**ZONING AMENDMENT
& SUBDIVISION STAFF REPORT****Date: June 5, 2008****APPLICANT NAME**

Amity Missionary Baptist Church

Amity Missionary Baptist Church Subdivision

Subdivision approval to create 2 lots, and Zoning approval to rezone the site from R-1, Single-Family Residential, and B-2, Neighborhood Business, to B-2, Neighborhood Business to eliminate split zoning for a proposed church.

SITE PLAN

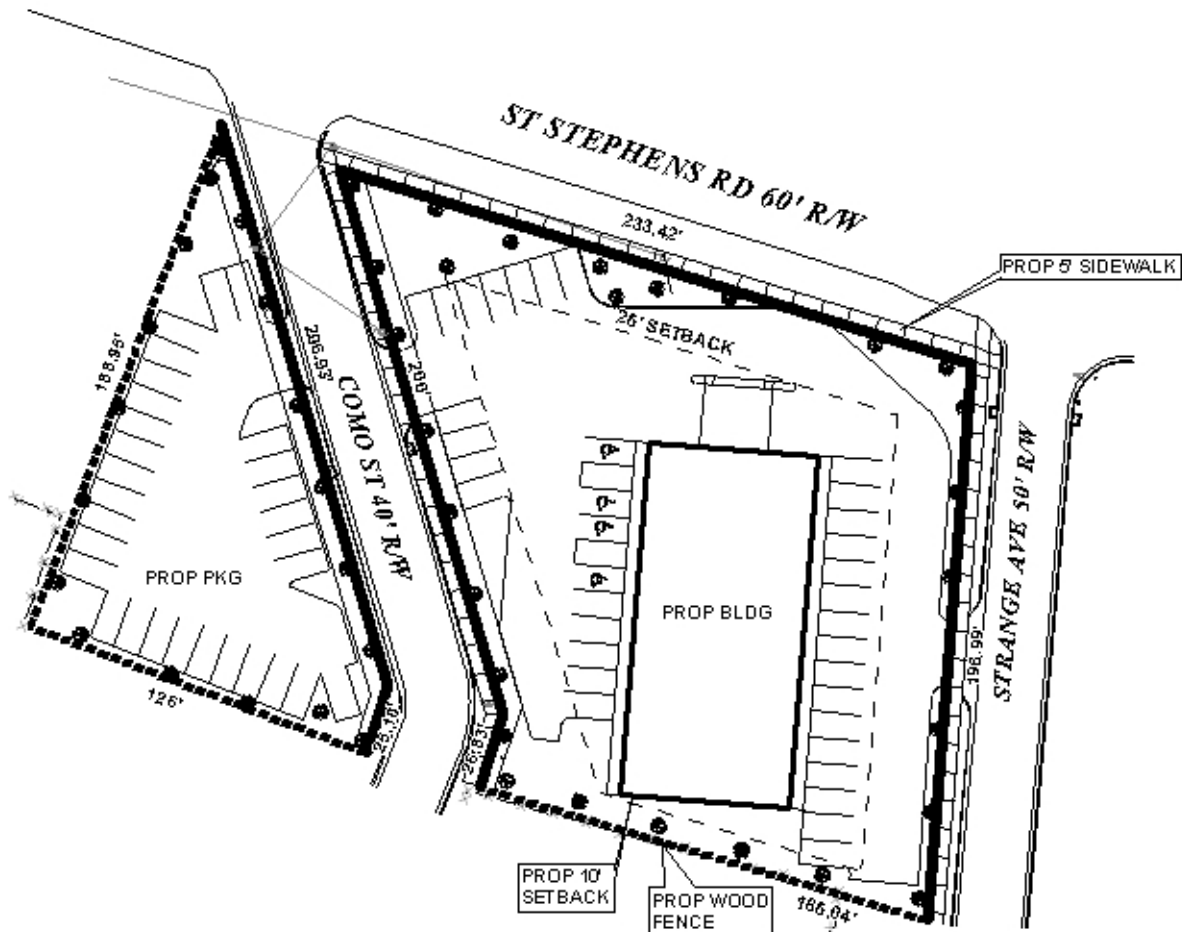
Driveway number, size, location, and design to be approved by Traffic Engineering and conform to AASHTO standards. Final approval for all driveways, proposed and existing will be given upon submittal of final plans. To eliminate conflicts in the parking areas some parking spots need to be removed or relocated. In the western lot the two spaces on the north side of the lot should be removed as well as the one parking space on the southeast end of the lot. In the east lot remove two spaces on the northwest end of the aisle located at the drive to eliminate conflicts with the driveway. Parking spaces located on the west side of the building on the south end of the aisle do not have adequate aisle width. Minimum aisle width is twenty-four feet. Changes should be made to accommodate the standard.

proposed onto St. Stephen's Road. Traffic Engineering has reviewed the site plan provided with the application, and has concerns regarding the layout of the parking area. As an application for Planned Unit Development will be required, a revised site plan should be prepared reflecting the comments provided by Traffic Engineering.

The site will abut residential zones to the South, thus a vegetative buffer or fence in compliance with Section 64-4.D.1. of the Zoning Ordinance will be required. The site plan should be modified to reflect either a fence or 10-foot wide vegetative buffer.

It should also be pointed out that some of the required landscape and frontage trees are placed in what could be the future right-of-way of Como Street, should a 50-foot wide right-of-way be required.

- 2) Revision of the site plan for the Zoning application to reflect Traffic Engineering comments (*To eliminate conflicts in the parking areas some parking spots need to be removed or relocated. In the western lot the two spaces on the north side of the lot should be removed as well as the one parking space on the southeast end of the lot. In the east lot remove two spaces on the northwest end of the aisle located at the drive to eliminate conflicts with the driveway. Parking spaces located on the west side of the building on the south end of the aisle do not have adequate aisle width. Minimum aisle width is twenty-four feet. Changes should be made to accommodate the standard.*);

- 3) Revision of the site plan to reflect dedication along Como Street sufficient to provide a City-standard sidewalk along the West side, as well as the corner radius for the Southeast corner of Como Street and St. Stephen's Road that complies with Section V.D.6. of the Subdivision Regulations;

- 4) Revision of the site plan to depict and label the minimum building setback line from all streets, modifying the setback line along Como Street to accommodate a possible 50-foot wide right-of-way;

- 5) Revision of the site plan to depict a sidewalk along the West side of Como Street;

- 6) Revision of landscape area calculations to reflect changes in the size of the site due to right-of-way dedication; and
- 7) Revision of the site plan to depict and label a buffer that complies with Section 64-4.D.1. of the Zoning Ordinance, where the site abuts residentially zoned property.

SUBDIVISION AND ZONING DETAIL

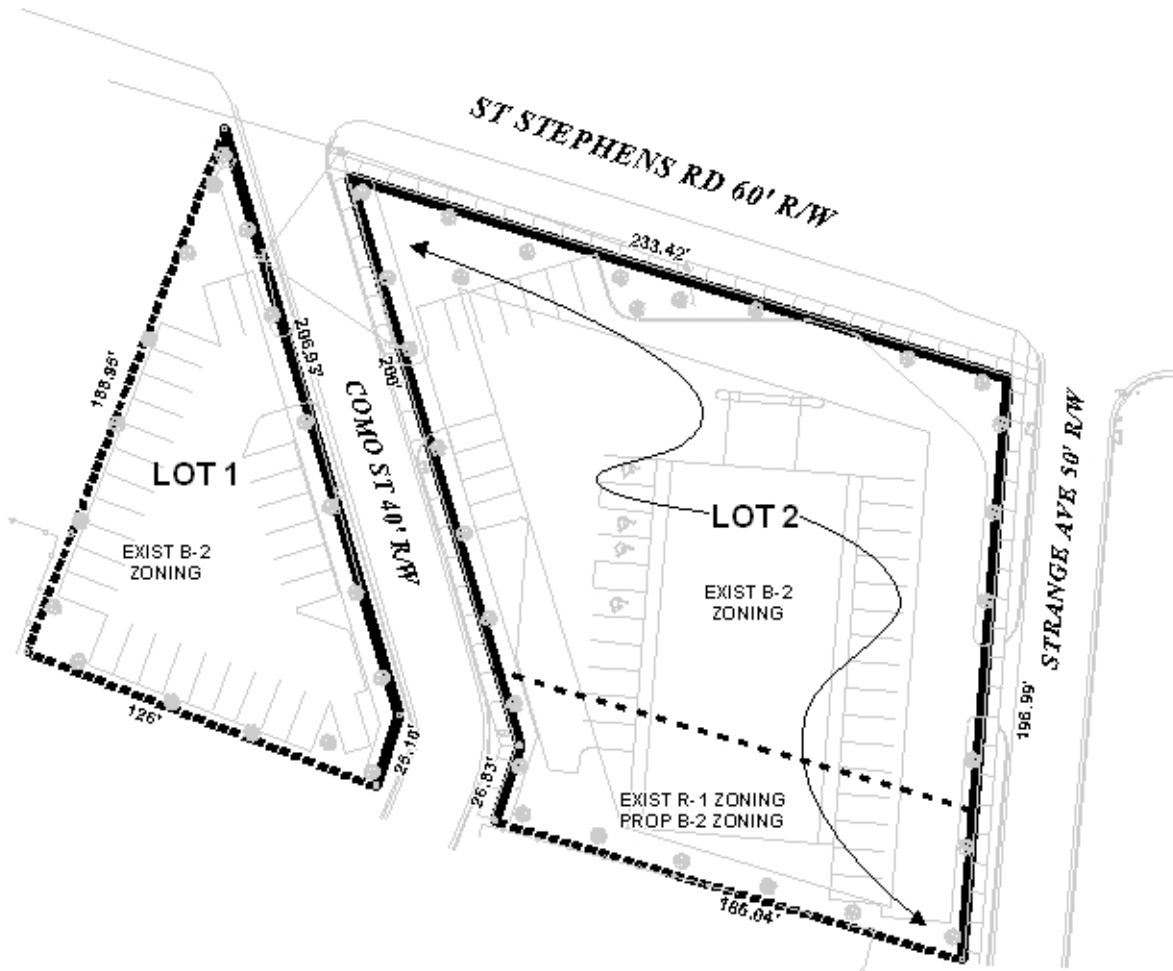
The site fronts onto St. Stephen's Road, a proposed major street, and onto Como and Strange Streets, both minor streets, however the right-of-way for Como is only 40-feet in width, which is below the minimum 50-feet normally required for minor streets. It appears that many streets in the vicinity have 40-foot right-of-ways. Dedication along Como Street may be necessary for proposed Lot 1, the parking lot, as insufficient right-of-way exists to provide a sidewalk on that side (the West side) of the street, which will serve as a stand-alone parking area: thus dedication sufficient to provide a City sidewalk should be required. Dedication will also be required on the East side of Como Street, at the Southeast corner where Como Street meets St. Stephen's Road: a radius of the lot corner in compliance with Section V.D.6. should be provided. The setback line for the remainder of Como Street should be adjusted to reflect a possible 50-foot wide right-of-way width, and the setback line should be depicted and labeled for all streets on the Subdivision plat.

The Subdivision plat, in addition to not showing the required minimum building setback, does indicate the size of each lot. The plat should be revised to depict the size of each lot in square feet, adjusted for any required dedication.

- 1) Revision of the plat to reflect dedication along Como Street to provide a City-standard sidewalk along the West side, as well as the corner radius for the Southeast corner of Como Street and St. Stephen's Road that complies with Section V.D.6. of the Subdivision Regulations;
- 2) Revision of the plat to depict and label the minimum building setback line from all streets, modifying the setback line along Como Street to accommodate a possible 50-foot wide right-of-way; and
- 3) Revision of the plat to label each lot with its size in square feet, adjusted for any required dedication.
